ADDENDUM NO. 8
DOUGALL AVENUE RAIL PEDESTRIAN UNDERPASS AND MULTI-USE TRAIL DESIGN-BUILD PROJECT
RFP NO. 156-18

January 25, 2018

KING LUMINAIRE COMPANY INC.				
840 WALKER'S LINE, P.O. BOX 7, BURLINGTON, ONTARIO, CANADA L7R 3X9		P.O. BOX 286 JEFFERSON, OHIO 1153 STATE ROUTE 46N U.S.A. 44047		
DRAWING NAME: APPROVAL DWG	DWG NUMBER 206A4071-6	DATE: 10/20/06	DWG BY: M.L.	REV. A
PROJECT/CUSTOMER: WINDSOR				CHK BY:

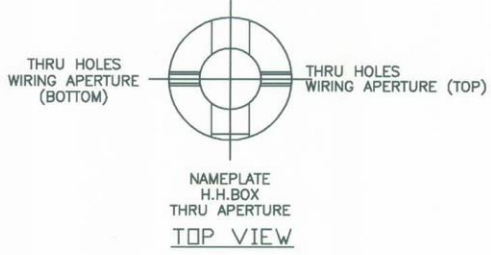
A "Luminaire Detail" drawing is provided as a minimum standard for the required lighting treatment and is similar to what was used at the Howard and Walker underpasses. The pedestrian luminaire on the back of the pole can be considered optional as the Design-Build team may chose an alternative pedestrian luminaire option.
